SERVICE BULLETIN

| BULLETIN NUMBER: | SB-0053 |

| PRODUCT DESCRIPTION: | MT-3 Crystal Operation for SR-39-1 with v7 Motherboard |

| DE REFERENCE / ECO: | CO 6636 |

FIGURE 1

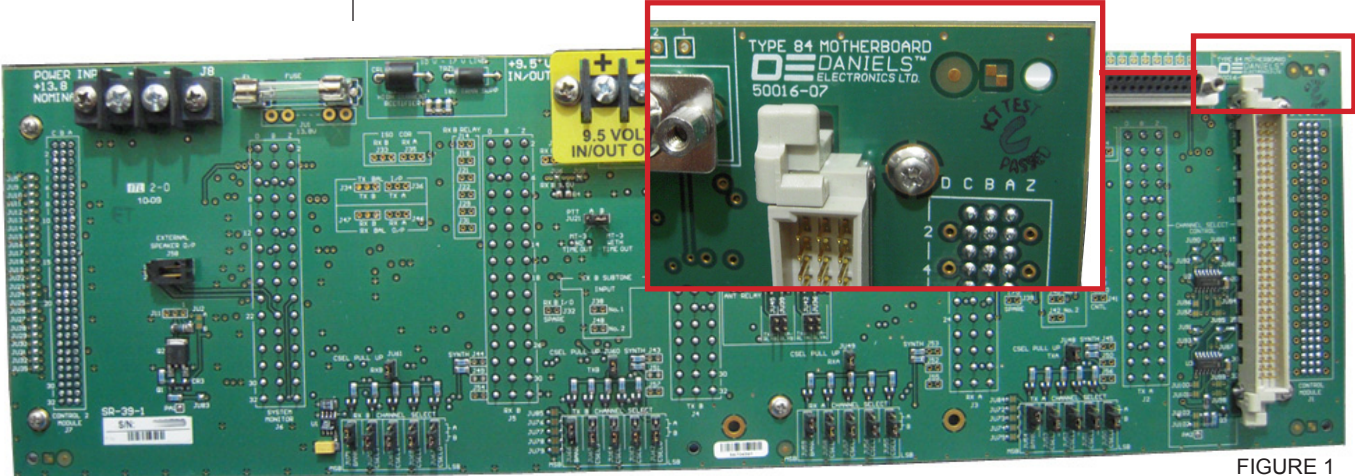
PROBLEM: Daniels has discovered that the MT-3 crystal radios are not compatible with subracks using motherboard PCB 50016 Version 07 and newer. For mainboard ID location, see Figure 1.

When a crystal module is installed in a subrack containing the Version 7 motherboard, the RF frequency offset of the radio can be pulled off by 5 kHz and 10 kHz. This is because there is a pull-up resistor on the D28 and D30 lines that Daniels needed to add during the subrack redesign to allow for proper operation of the AM receivers and transmitters front panel handle display.

SOLUTION: In order to make the crystal units work in the new subracks, the following resistors must be removed from the motherboard (for illustrations, see Figure 2):

For RXA MT-3 Crystal Operation: R9, R10

WAS 1150-5B1003FP RES., SM, 100K 1206, 1%,100ppm KOA RK73H2BTDD1003F
NOW Not Installed

WAS 1150-5B1003FP RES., SM, 100K 1206, 1%,100ppm KOA RK73H2BTDD1003F
NOW Not Installed

NOTE: Once these resistors have been removed, the subrack motherboard will no longer allow operation of the AM front panel handle displays.
Removing these resistors will not effect MT-4E operation.
